SUBJECT: APPEAL OF THE PLAN COMMISSION/ARCHITECTURAL REVIEW BOARD'S DECISION TO APPROVE A SITE PLAN AND ARCHITECTURAL PLANS FOR NEW CONSTRUCTION OF A TOWHOME PROJECT AT 114, 124 AND 134 GAY AVENUE

**Request for Reconsideration and Notice of Appeal
From ARB/Plan Commission of January 21, 2020
Regarding 114, 124 and 134 Gay Avenue**

Statement of Appeal: Susan Hamra and Colin Butterfield, owners and residents of 117 Crandon, immediately to the east of 114 Gay Avenue, appeal the decisions of the ARB/Plan Commission approving the Site Plan and Architectural Review for the new town homes at 114, 124 and 134 Gay Drive. Appellants do not appeal the rezoning decision.

Section 405.2210 Setback Requirements

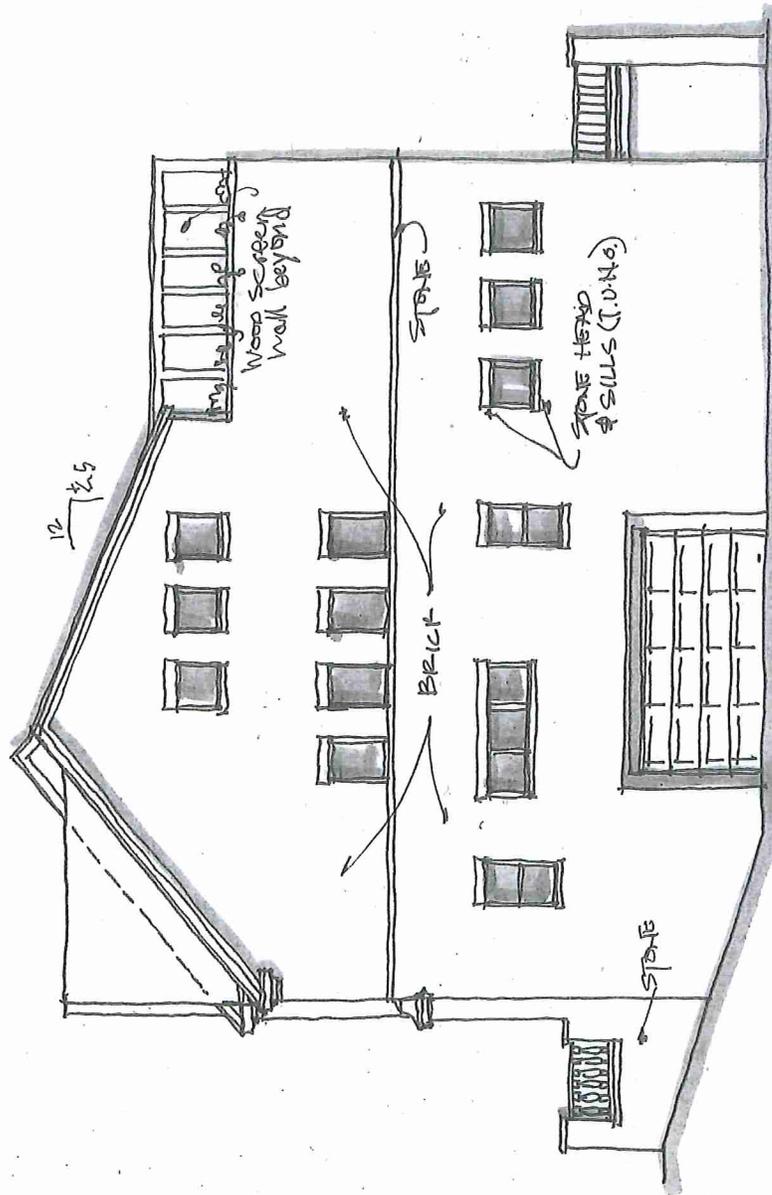
2. Ten Foot "Retaining Wall" Is A Solid Concrete Structure and Should Meet Setback Requirements.

Section 405.2210A.2, Exhibits C and D attached, requires a rear yard setback of 30 feet. It was announced at the meeting that all set back requirements were met but no examination of the facts supporting that statement occurred.

What has been referred to as just a "retaining wall" is a concrete wall with stone veneer attached which exceeds the height limitation for a solid fence and is akin to a wall of a building. Please see picture of material in Exhibit E. It certainly defies the spirit of the ordinances that a stone "retaining wall" can exceed fence limitations and approximate height of some one story buildings yet not follow setback requirements.

This ten (10) foot high wall will be less than 10 feet from our west property line. The setback requirement is undoubtedly designed to afford green space between houses and light to each yard creating an open neighborhood environment. The placement of the massive wall does not afford that and is in violation of the setback requirement.

Staff response: A fence or a retaining wall is not considered a "structure" by the zoning code. But, if the retaining wall was considered a structure, then the location and height, as approved, in fact meet the setbacks and height requirements of the R-4 district. The minimum setback requirement for accessory structures in the R-4 district is 5 feet and the wall, as approved, is set back 8 feet; the maximum allowable height of an accessory structure is 20 feet, and the wall, as approved is 10 feet.
